# Product Change Notice

## 3M™ Mini D Ribbon (MDR) Metal Junction Shell for Flat Cable

Issue Number: 752  
Date: April 13, 2010

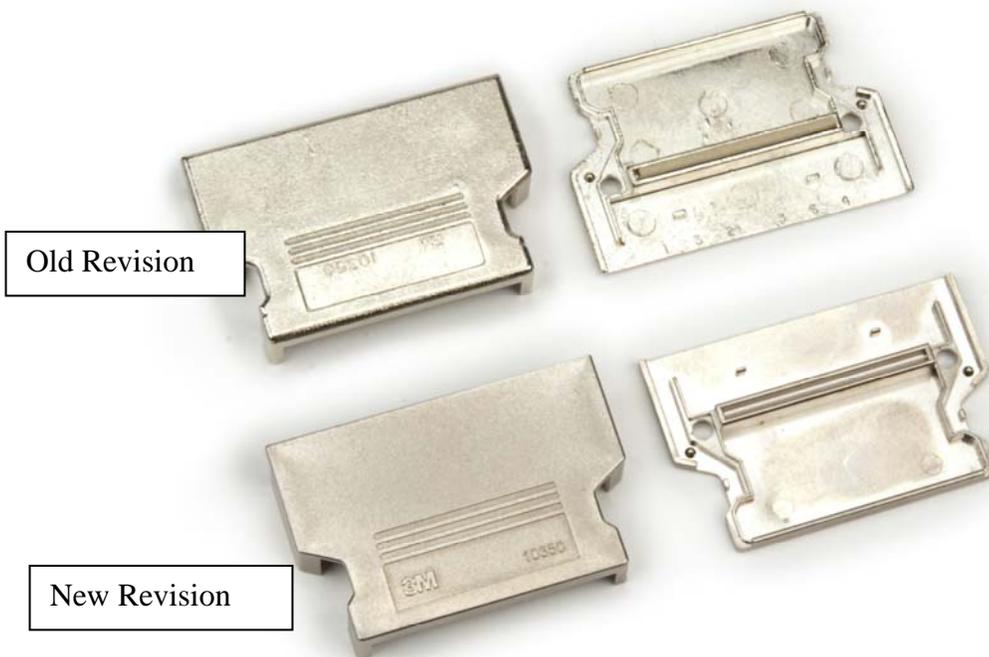
Please refer to the below picture for some visual indicators (NOTE: thumbscrew model not shown):

- Surface texture has a slightly different, but more uniform, look and feel.
- 50-position only: 3M logo and part number series markers are rotated 180 degrees.
- Mirror finish has been removed from the logo and part number area.

- Screw hole has changed from a threaded hole to an unthreaded hole.
- Supplied screws have been changed from a Philips head to a Pozidriv #1 head, self-tapping screw. Owing to the increased torque requirements of a self-tapping screw, it is recommended that only designated Pozidriv screwdriver bits be used to assemble the kit after termination. These are broadly available from most hardware suppliers.
